MONTGOMERY COUNTY PLANNING DEPARTMENT
THE MARYLAND-NATIONAL CAPITAL PARK AND PLANNING COMMISSION

SUBJECT: **Special Exception S-2736**– Request of DavCo Restaurants, Inc. to establish a Drive-in Restaurant (Wendy's) located at the southeastern corner of the intersection of Vital Way and Randolph Road in Silver Spring.

S-2736: Wendy's Colesville

SPECIAL EXCEPTION SITE PLAN (S-2139)
WENDY'S COLLETSVILLE
LOT 22
PLAT NO. 21715

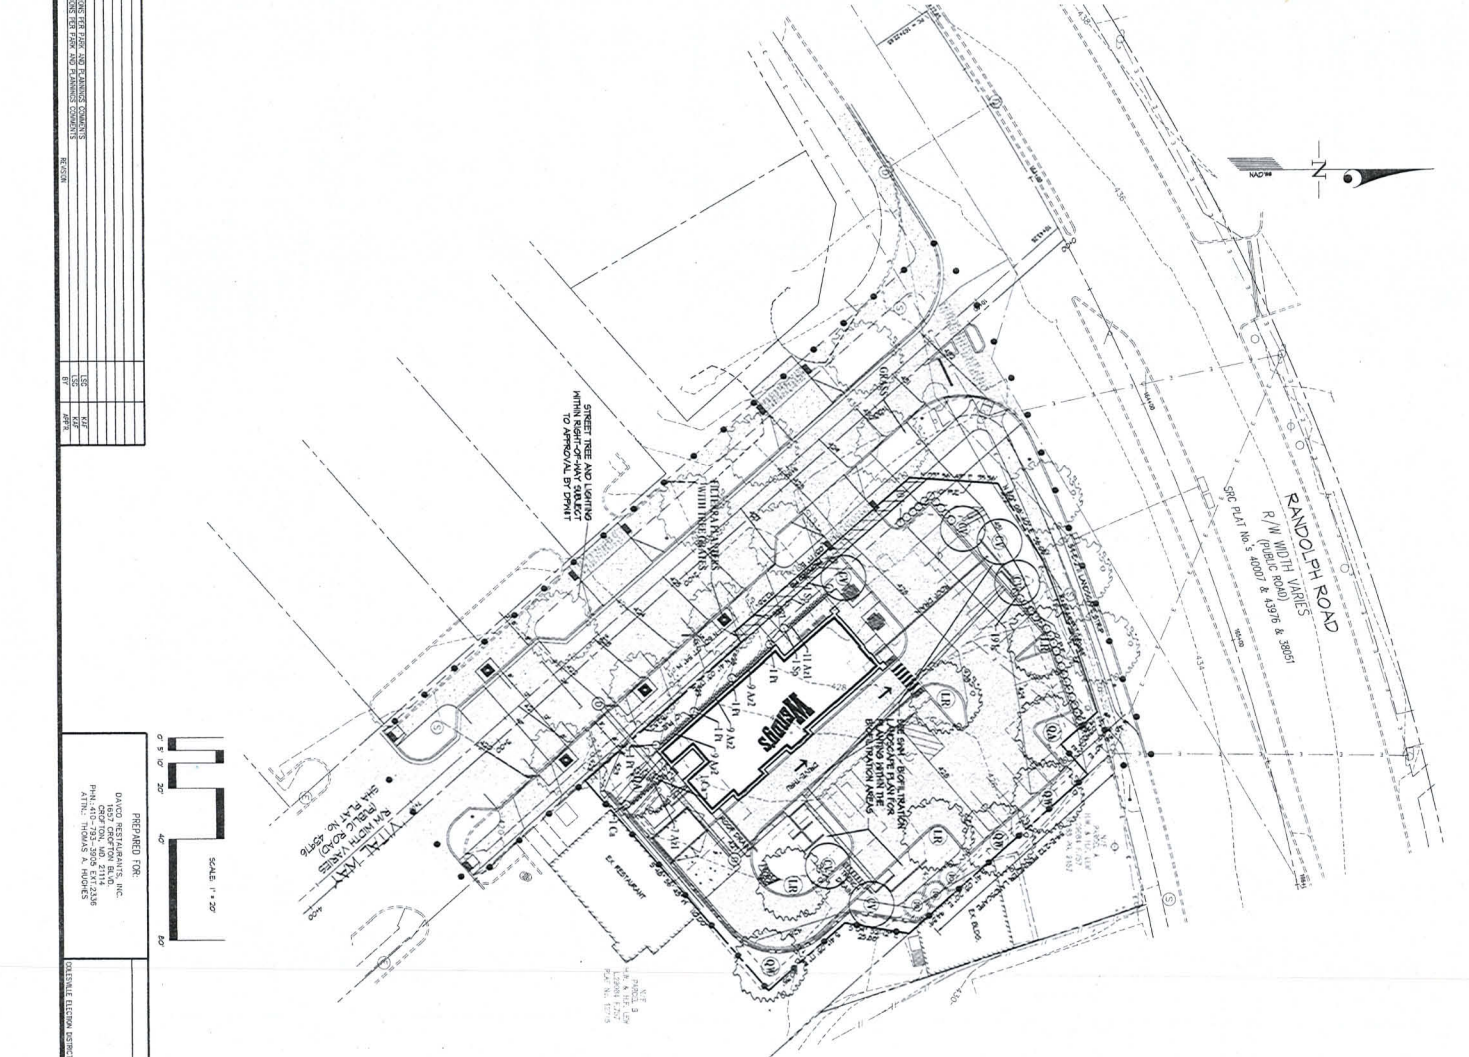
It is important for streets with a main-street, pedestrian-oriented design to have few curb cuts and adequate sidewalks. The proposed design, as submitted on the plans stamped "Received Dec, 02, 2008", proposes one vehicular entry near the intersection with Randolph Road, ample sidewalks along Vital Way, and direct pedestrian access to the restaurant from these sidewalks. The location of the access drive and internalized vehicular circulation minimizes conflict-points with pedestrians and allows for more of the site to be landscaped rather than paved. The sidewalks, both internal and along the street, will encourage pedestrian use; outdoor benches and tables will enhance the main-street feel envisioned for Vital Way.

SPECIAL EXCEPTION - LANDSCAPE PLAN
WENDY'S COLETSVILLE
 PLAT NO. 2177S
 SCALE: 1"=20'
 DATE: 2008

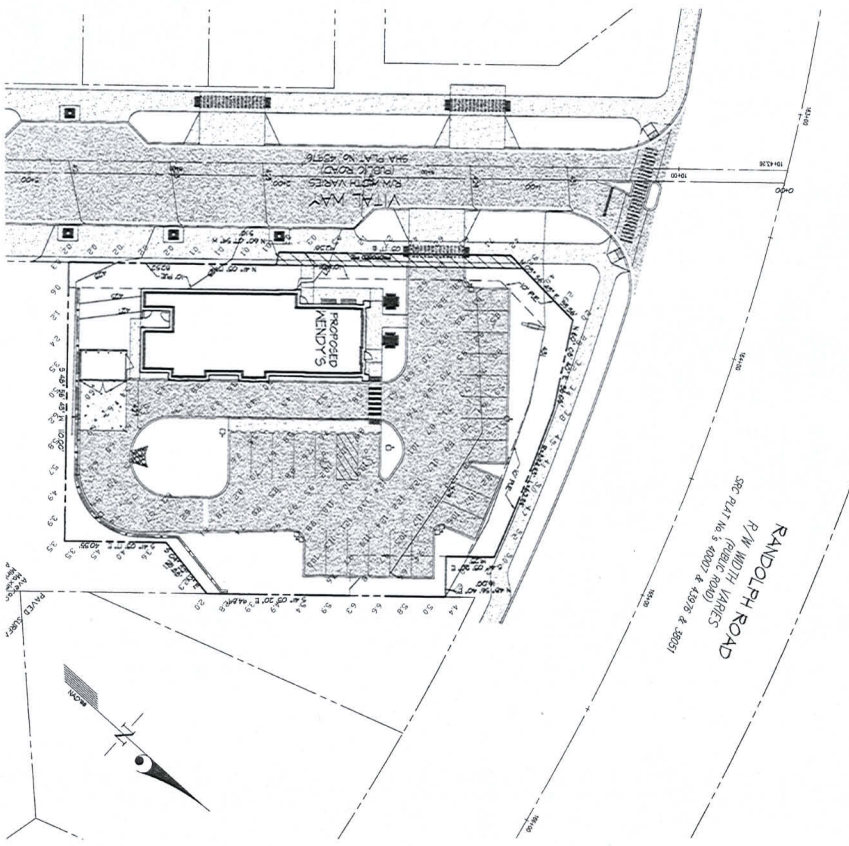
The landscaping and lighting concept is appropriate for this type of site and setting. The bio-retention areas are an environmentally wise use of green space in and around the parking lot. The screening of the parking and trash facilities will help maintain a welcoming and green atmosphere. The trees throughout the site and the plantings around the building soften the architecture and parking areas and will provide a different experience than is usually seen on such sites.
